**MODIFICATION SHEET NO. RDSO/2010/EL/MS/ 0390 Rev.'0' Dated 31.12.10.**

Paralleling of interlocks of EP contactors and relays of three phase locomotives to improve reliability.

Schematic Pos. 8.41  
Contactor for discharge resistor

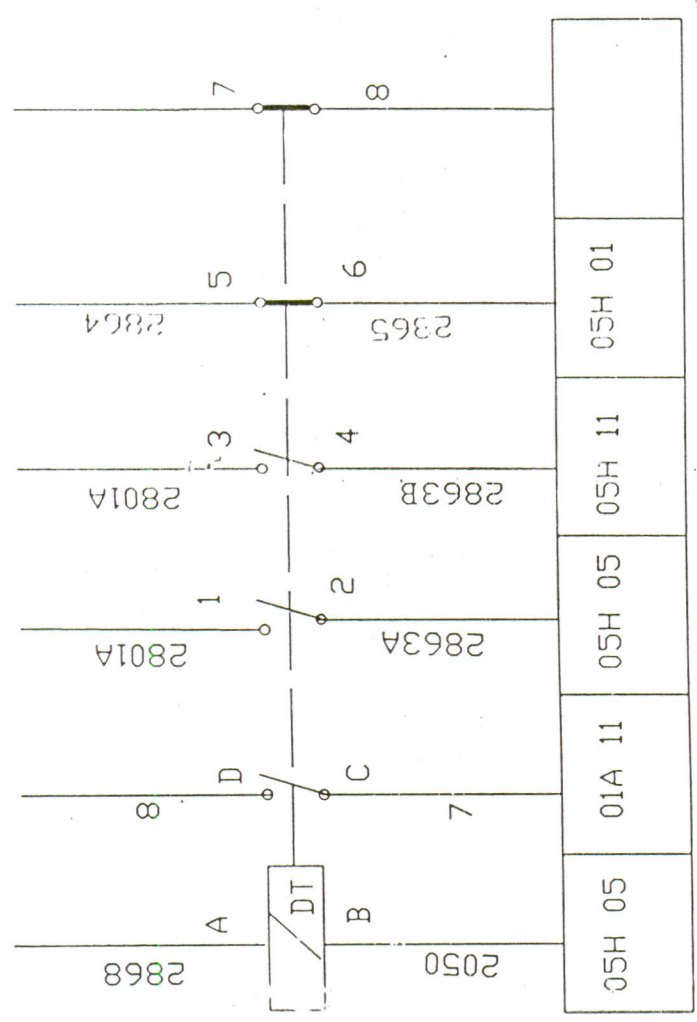
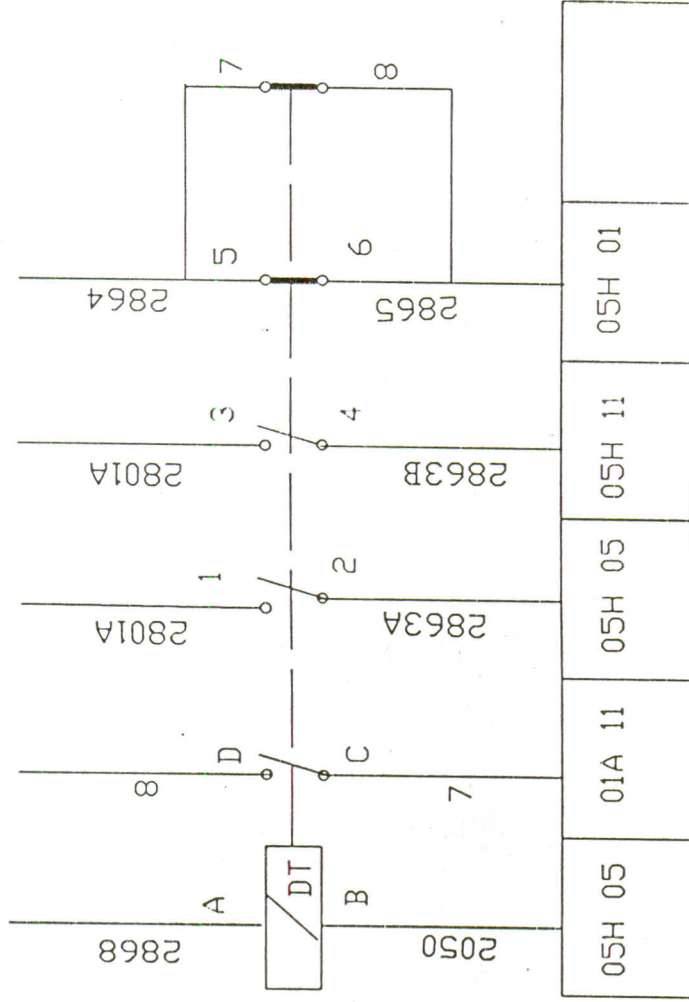
Loco no. 30252 failed on line on 27.10.10, while hauling train no. 2301 due to harmonic filter isolation. During investigation, it was observed that normally closed (NC) auxiliary interlock of discharging resistance contactor of harmonic filter (8.41) was not passing supply thereby preventing the harmonic filter contactor ON/OFF (8.1) to close, which resulted into harmonic filter isolation and loco speed was not increasing more than 40 km/h. In order to avoid such type of failures online series and paralleling of frequently operated interlocks (interlock operates, every time throttle comes to zero position) and moderately operated (interlocks operate, every time VCB operates) with spare interlocks available in the locomotive have been recommended.

Discharging resistor						be paralleled to used NC interlock 5&6.
2	136.4	Auxiliary Contactor VCB	00	00	01	03	SB1 Cubicle	The spare NO interlock 3&4 is to be paralleled to used NO interlock 1&2
3	54.2/1	Time relay for MRB1	01	01	01	01	HB1 Cubicle	The spare NC R3,R4 interlock is to be connected in parallel to used NC interlock R1,R2.
4	54.2/2	Time relay for MRB2	01	01	01	01	HB2 Cubicle	The spare NC R3,R4 interlock is to be connected in parallel to used NC interlock R1,R2.
5	8.1	Contactor Filter ON/OFF.	01	00	02	0	FB Cubicle.	As there is no spare NC interlock hence auxiliary cam switch complete (part no. A5514 normally closed) of SMGR is required to be put in the contactor and to be made parallel with used NC 2A&2B interlock.

Sl. No.	Cont./ Relay No.	Description	Nos. of NC Interlocks.		Nos. of NO Interlocks.		Location	Remarks
			Used	Spare	Used	Spare		
1	8.41	Contactor	01	01	02	01	FB Cubicle.	The spare NC interlock 7&8 is to

Sch. Pos. 8.1

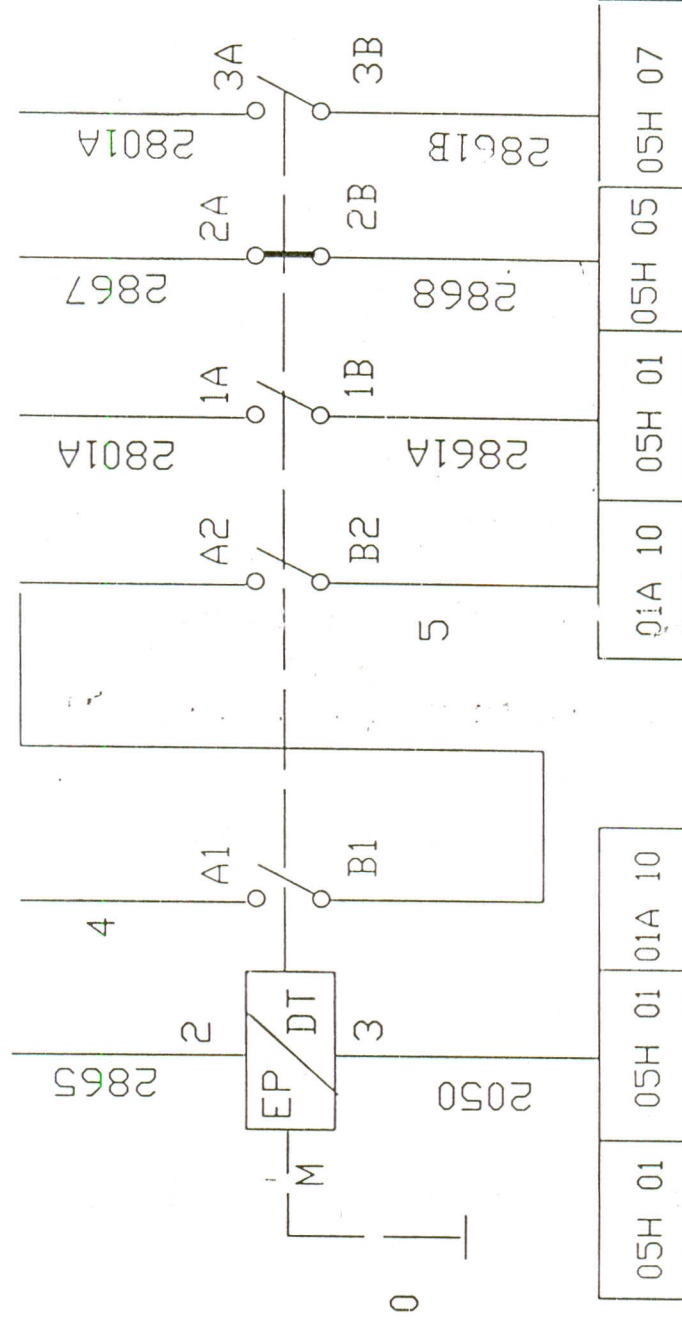
**11.0** The manufacturer of EP contactor M/s. Secheron Ltd. (M/s.PPS International/Noida) have been advised to provide one NC interlock as spare in harmonic filter contactor ON/OFF (8.1) vide this office letter of even no. dated 11.01.11.

X = Auxiliary Cam  
Switch Complete, Part  
No. A5514 of SMGR.
